2. BT/WIFI antenna matching optimization.

All of these changes listed above have been applied to the samples used for lab tests.

P708-B1-BOT

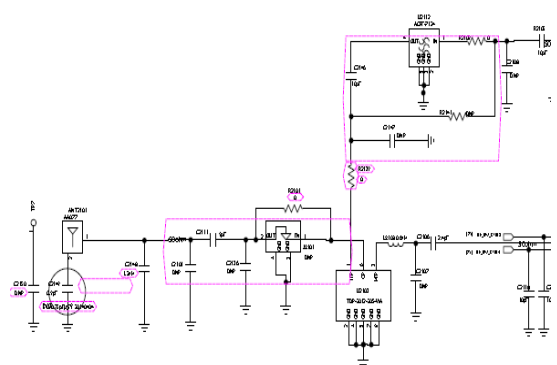
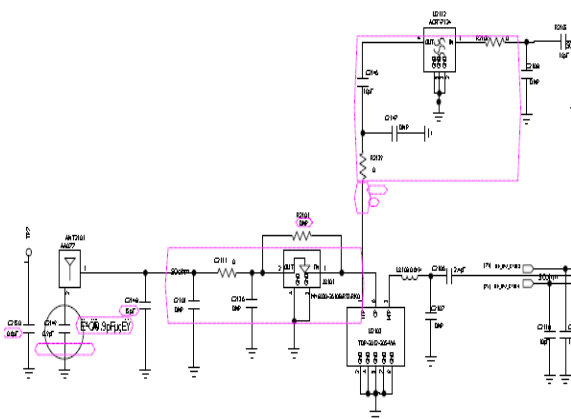
C2149 change from 0402 0.75 PF to 0402 0.9 PF;
C2150 change from 0402 0.5 PF to 0402 DNP;
C2148 change from 0402 9 PF to 0402 1.2NH;
J2101 change from MM8030-2610B/RJ3/RK0 to DNP;
R2101 change from DNP to 0201 0R.

P708-B1-BOT

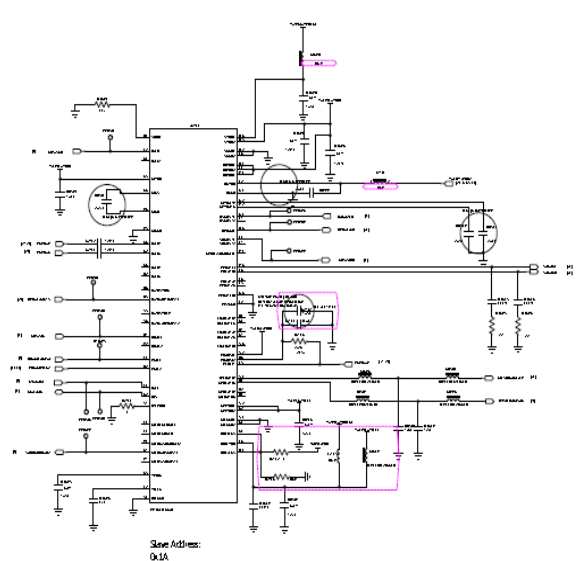
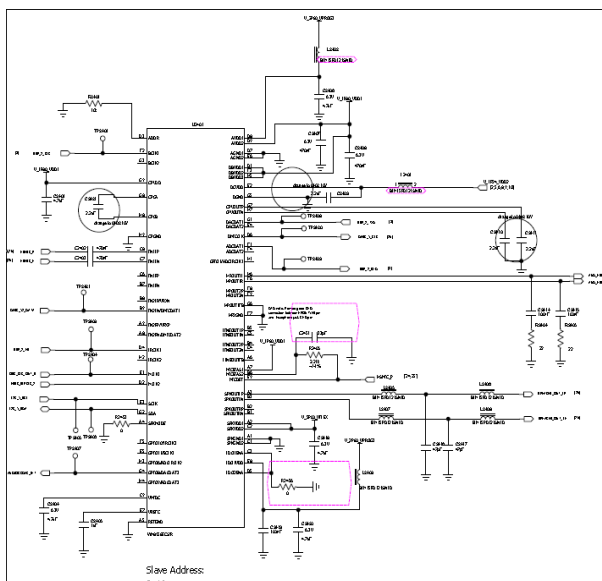
3. Optimization of audio circuit.

Add R2457 0R 0201 L2410;
Delete R2456, L2401, L2402, L2409.

P708-B1-BOT

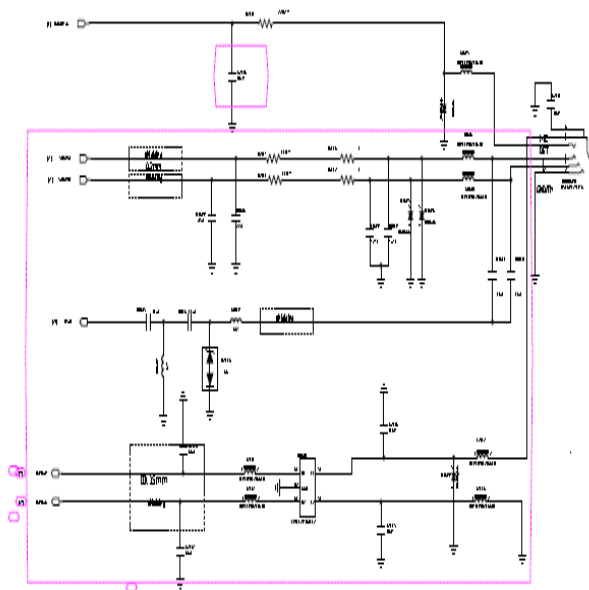
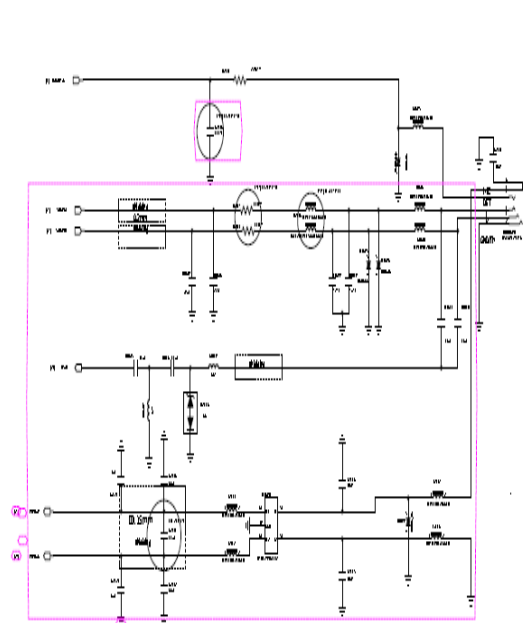
4. Optimization Headset interface circuit.

Add C2452 4.7uF 0402;
 R2506 change from 0R 0402 to BLM15AG601SN1D;
 R2507 change from 0R 0402 to BLM15AG601SN1D;
 C2506 change from 0201 DNP to 0201 100nF;
 R2504 change from 10R 0201 to 33R 0201;
 R2505 change from 10R 0201 to 33R 0201;
 Add C2515 33pF 0201.

P708-B1-BOT

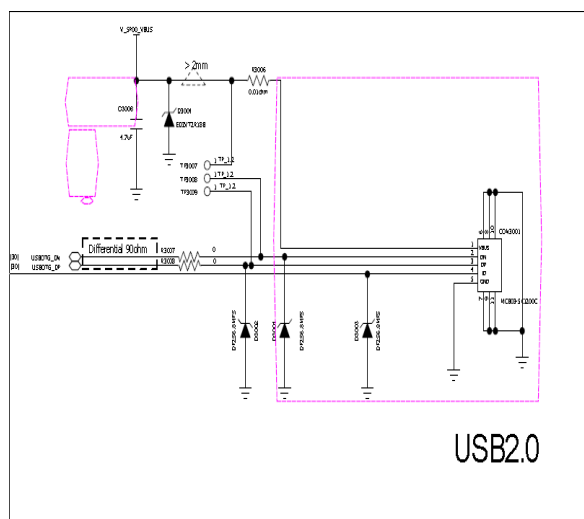
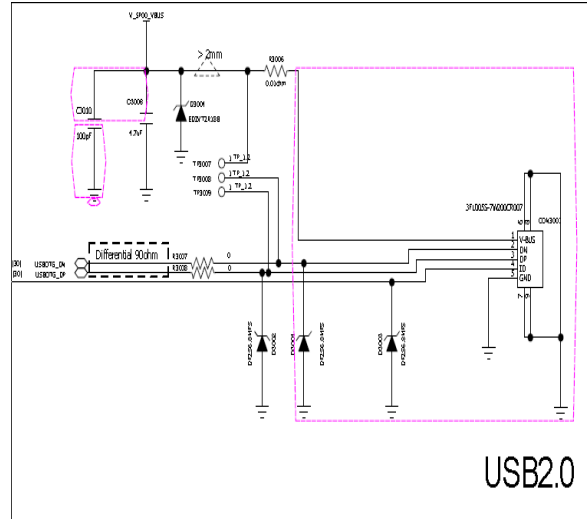
5. Replacing the USB connector.

Connector changed from CON3001 MCB03-5K1200C to 3FU005S-7W200CR007.

P708-B1-BOT

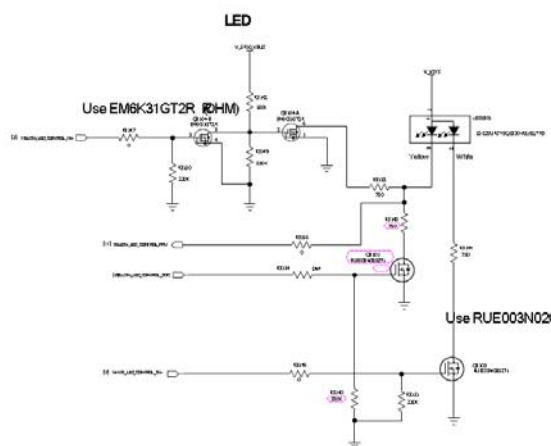
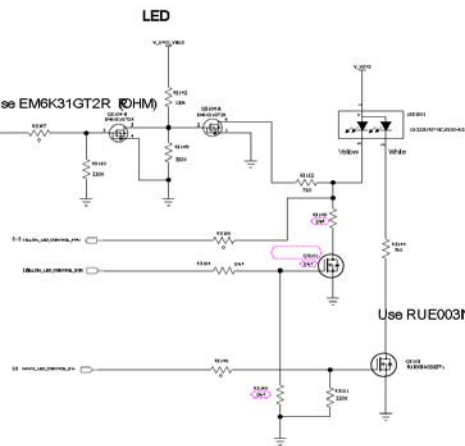
6. Optimization of LED lamp control circuit.

Q3101 change from RUE003N02GZTL to DNP;

R3148 change from 750 R to DNP;

R3140 change from 220K to DNP.

P708-B1-BOT

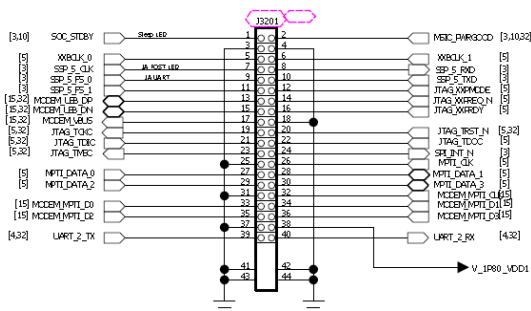
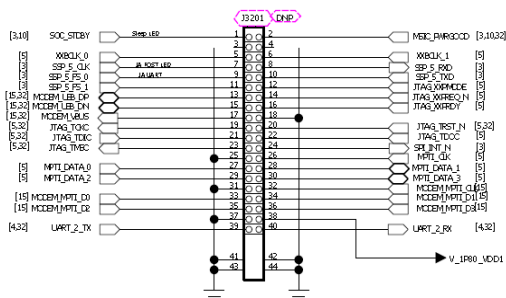
7. Delete Debug connector DNP J3201.
